Access Compliance Report

Public Rights-of-Way

Intersection ID: 42772	Main Street: JEANETTE_CR	Cross Street: SWANSONG_LN	Location: E
ADA ID: 9A1B4A265392	Ramp Type: Perp	Initial Pass/Fail: Fail	Overall Compliance: No
Severity Score: 12.5			
Codes/Mitigation Info/Possible Solution		Field Measurements/Component Compliance

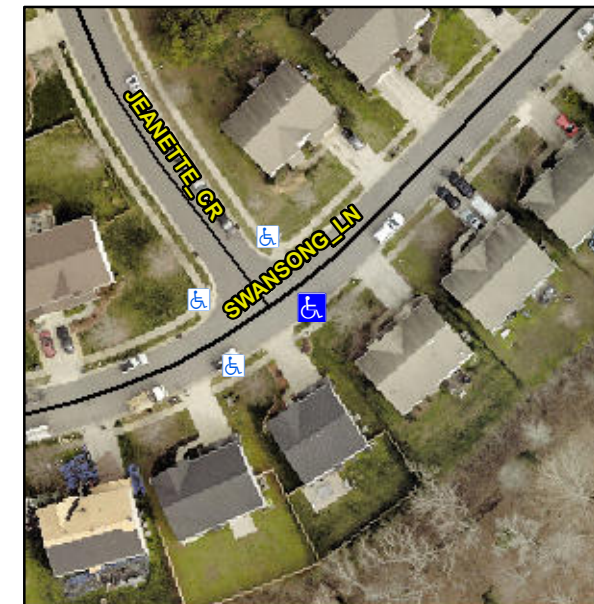
Not Found, R304.2.2

Compliance	Description	Data	Compliance	Description	Data
N/A	Ramp Length (in)	48.0	No	Ramp Slope (%)	8.5
Yes	Ramp Width (in)	50.5	Yes	Ramp XSlope (%)	1.1
N/A	Flare Type LT	N/A	N/A	Flare Type RT	N/A
N/A	Flare Slope LT (%)	N/A	N/A	Flare Slope RT (%)	N/A
N/A	Flare Traversable LT?	N/A	N/A	Flare Traversable RT?	N/A
N/A	Landing Length (in)	N/A	N/A	DWS Provided?	N/A
N/A	Landing Width (in)	N/A	N/A	DWS Contrast?	N/A
N/A	Landing Slope (%)	N/A	N/A	DWS Length (in)	N/A
N/A	Landing X Slope (%)	N/A	N/A	DWS Full Width?	N/A
N/A	Landing Curb? (Y/N)	N/A	N/A	DWS Offset (in)	N/A
N/A	Shared Landing?	N/A			
N/A	Gutter Ponding?	N/A	N/A	Gutter Slope (%)	N/A
N/A	Gutter Lip Ht (in)	N/A	N/A	Gutter X Slope (%)	N/A
N/A	Painted X Walk1?	No	N/A	Painted X Walk2?	N/A
	X Walk 1 Direction	To NW		X Walk 2 Direction	N/A
N/A	X Walk 1 Width (in)	N/A	N/A	X Walk 2 Width (in)	N/A
	X Walk 1 Slope (%)	6.7		X Walk 2 Slope (%)	N/A
	X Walk 1 X Slope (%)	1.5		X Walk 2 X Slope (%)	N/A

Remove & Replace Entire Ramp.
